Re: Environmental Protection Agency's (EPA's) "Oil and Natural Gas Sector: Emission Standards for New and Modified Sources" at 80 FR 56593 (September 18, 2015)

API Comments on the Proposed Rulemaking – Standards of Performance for New Stationary Sources: Oil and Natural Gas Production and Natural Gas Transmission and Distribution

Docket ID No. EPA-HQ-OAR-2010-0505

Figure 12-1 Current EPA Flare Velocity Limits

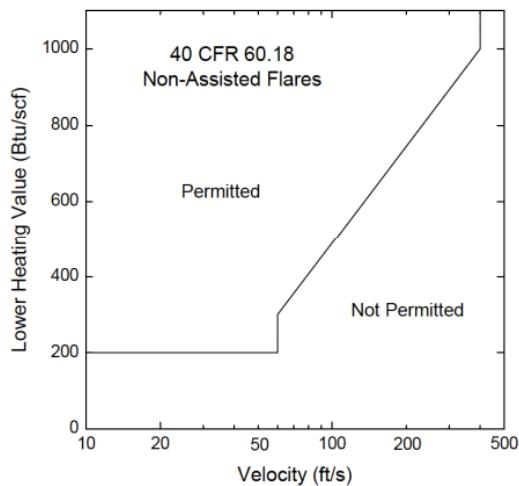
The velocity limits in 40 CFR 60.18 were originally promulgated on January 21, 1986 and are graphically depicted below. The figure shows flame exit velocities in feet-per-second (fps) along the x-axis and lower heating value of the waste gas in Btu/scf along the y-axis. A minimum heat content is required of 200 Btu/scf for unassisted flares or 300 Btu/scf for assisted flares up to 60 fps, where the required heat content increases as a function of exit velocity until a maximum allowable velocity of 400 fps is reached.

The 1986 limits appear to originate with only four data points from these tests – the average value at the upper limits of each study. The 60 fps, 300 Btu/scf limit for steam-assisted flares was set based on a single data point -- McDaniel 1983¹¹ test 57. The 200 Btu/scf limit for unassisted flares was also set based on a single data point – McDaniel test 59. These tests were performed on an 8.6-inch steam-assisted flare fueled with a propylene/nitrogen mix. The data are shown in Figure 12-3. The data are binned by heat content, where red dots indicate test runs whose combustion zone net heating value (NHVVG) is less than 270 Btu/scf, green dots indicate test runs with NHVVG between 270 and 500 Btu/scf, and blue indicate test runs with NHVVG greater than 500 Btu/scf.

All of the data collected, including the data used previously to set current limits as well as recently collected data, show that high velocity flaring results in high flare combustion efficiency (>96.5%). Previous limits were based solely on lack of data at higher flare exit velocities. There is no indication either in the 1980's studies or the more recent flare studies that high velocity flaring contributes to poor combustion efficiency.

Figure 12-2 A Comparison of Combustion Efficiency vs Velocity for McDaniel 1983

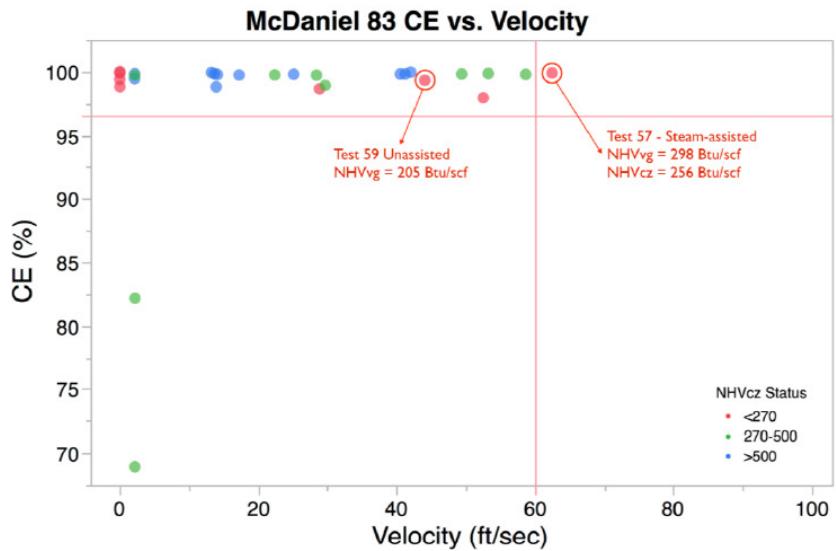
McDaniel did not collect data at velocities higher than 60 fps. At the 60 fps upper limit of the data, combustion efficiency remained very high and with no evidence of a trend toward lower combustion efficiency. These data were used to establish the 60 fps velocity limit although there is no evidence that operating at higher velocities results in degraded combustion efficiency.

Figure 12-3 A Comparison of Combustion Efficiency vs Velocity for Pohl 1984

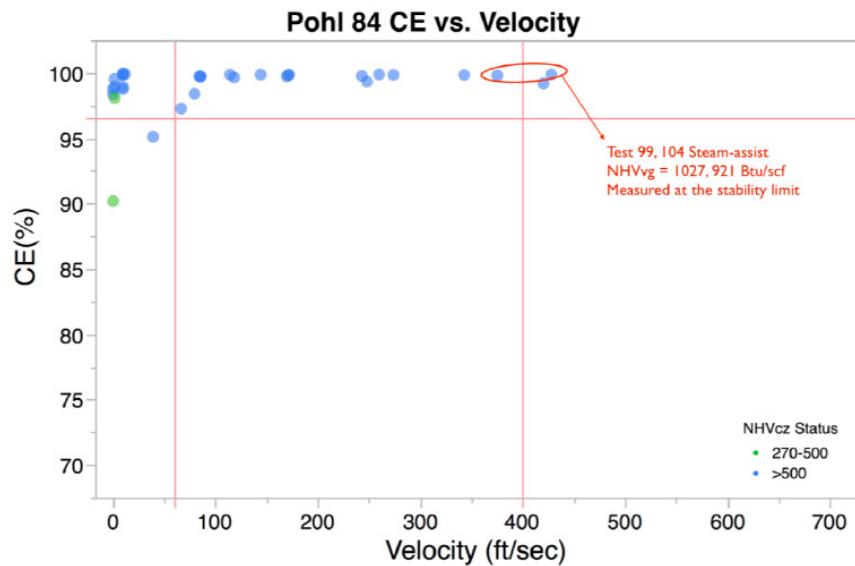
The 400 fps, 1,000 Btu/scf limit appears to be set based on two data points from flame stability test runs 99 and 104 from Pohl 1984.¹² That study was performed on a 3-inch steam assisted flare fueled with a propane/nitrogen mix. These data are shown in Figure 12-3. The data are binned by heat content, where green dots indicate test runs with combustion zone net heating value (NHVCZ) between 270 and 500 Btu/scf and blue indicate test runs with NHVCZ greater than 500 Btu/scf.

Similarly to the data used to establish the 60 fps limit, data collected in this study were not collected at velocities higher than the upper limit of 400 fps. As in McDaniel 83, Pohl 84 showed no evidence of a trend towards lower combustion efficiency at the upper velocity limit measured. These data were used to establish the 400 fps limit although there is no evidence that operating at higher velocities results in degraded combustion efficiency.

Figure 12-4 A Comparison of Combustion Efficiency vs Velocity for All Publicly Available High Velocity Flare Tests binned by NHVCZ Range

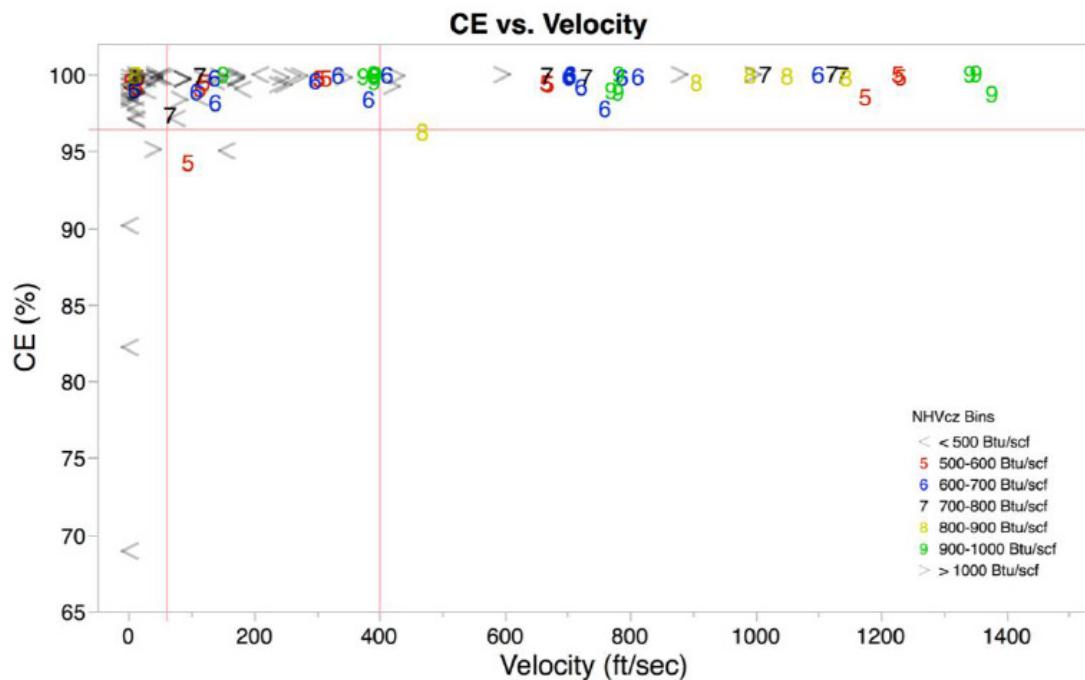
High Velocity Flare Test Data Figure 12-4 shows all data from publically available high velocity flare tests as of October 2014. Some low velocity data are also included to the extent that they were measured during a test series including high velocity data. Data includes the 1980's flare studies referenced above as well as more recent studies (Marathon Garyville¹⁵ and Dow¹⁶). This data is similarly displayed based upon combustion efficiency (CE) as a function of exit velocity in fps. The data is binned by NHVCZ in groups of 500 Btu/scf. Only data with NHVCZ > 270 are included.

Almost all of the low velocity data that also have low CE have NHVCZ values less than 500 Btu/scf. Additionally, virtually all of the test runs with velocity greater than the current limit of 400 fps, were conducted at NHVCZ values less than the current 1,000 Btu/scf limit. This graph clearly shows that high combustion efficiency above the current limits is not only possible, but that it is assured based upon available test data.

Figure 12-5 A Comparison of Flame Lift-Off and Combustion Efficiency from Pohl 84

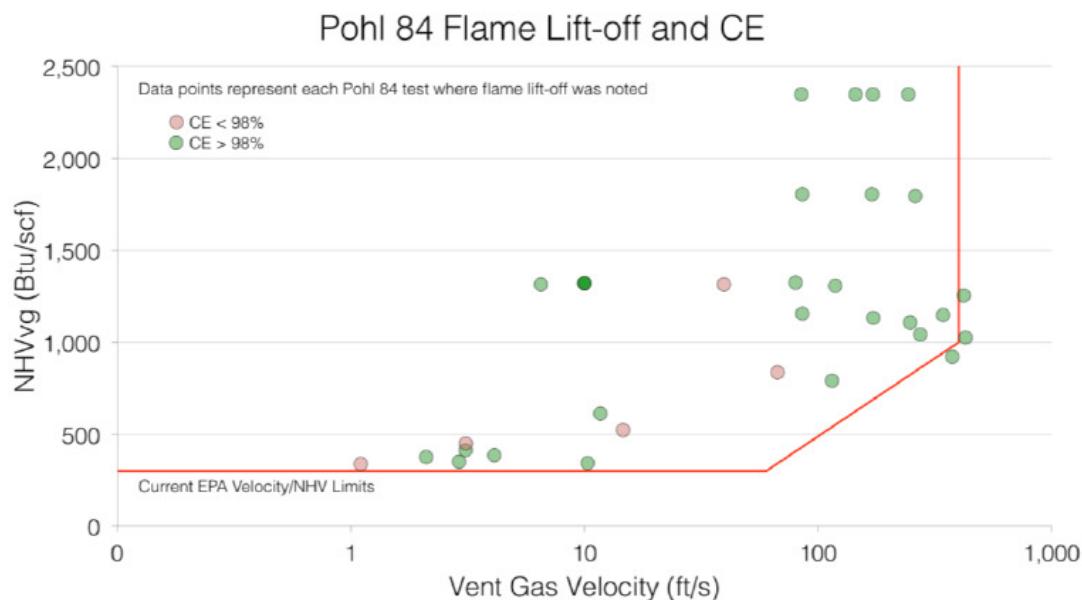
While there is no doubt that Pohl’s definition results in unacceptable flare performance, there is little evidence that flame lift-off has any correlation either positive or negative to combustion efficiency. Figure 12-5 shows every data point from Pohl 84 where flame lift-off was noted in the report.

Twenty-seven of the 32 lifted flames showed high combustion efficiency. None of the remaining five points had measured combustion efficiency below 91%. Figure 12-5 clearly shows that flame lift-off does not affect combustion efficiency over a wide range of velocities and net heating values.

Figure 16-1 AAAGRP Discount from B = 4.5% Method Comparison (2011)

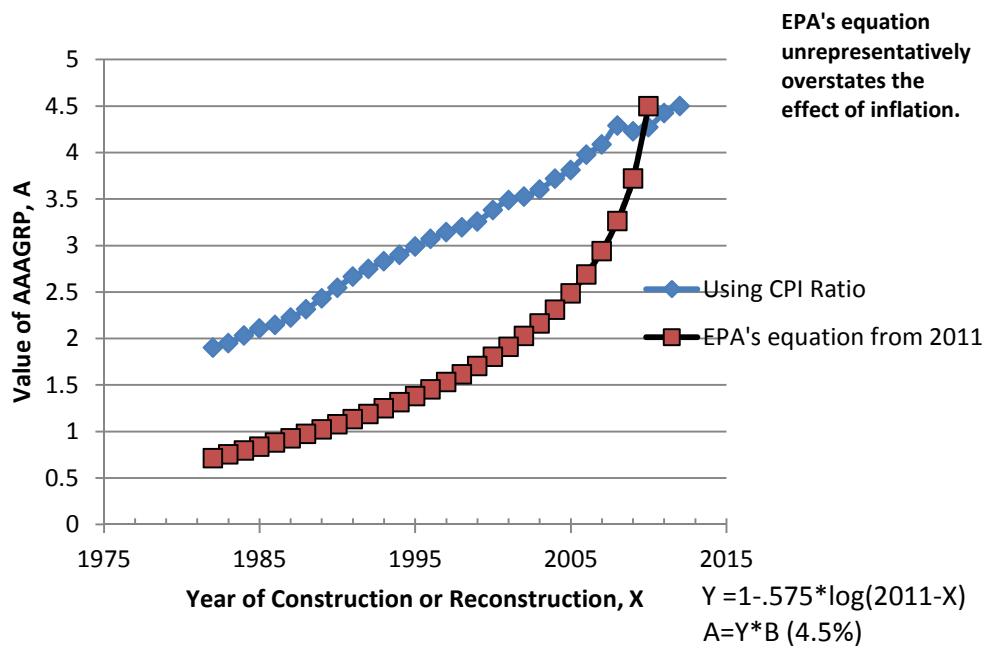
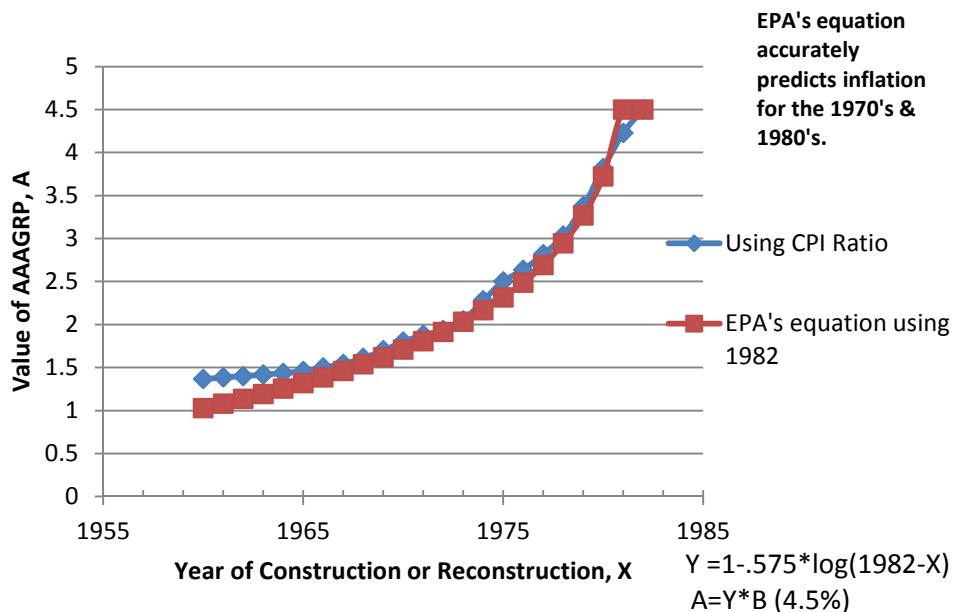
Figure 16-1 and Figure 16-2 depict a comparison of the two equations showing the value of A, the red curve using the proposed equation $Y = 1 - 0.575 * \log(2011-X)$, and the blue curve showing the equation above using 2012 price data. This demonstrates that the equation proposed by the EPA unrepresentatively overstates the effect of inflation in terms of discounting the value of B. The second graph (Figure 16-2) shows that using $Y = 1 - 0.575 * \log(1982-X)$, and 1982 as the date of component price data, the value of Y predicts inflation adequately for the late 1970s and early 1980s.

In addition, EPA must ensure that the definition of expenditure is not retroactive to eliminate interpretation issues.
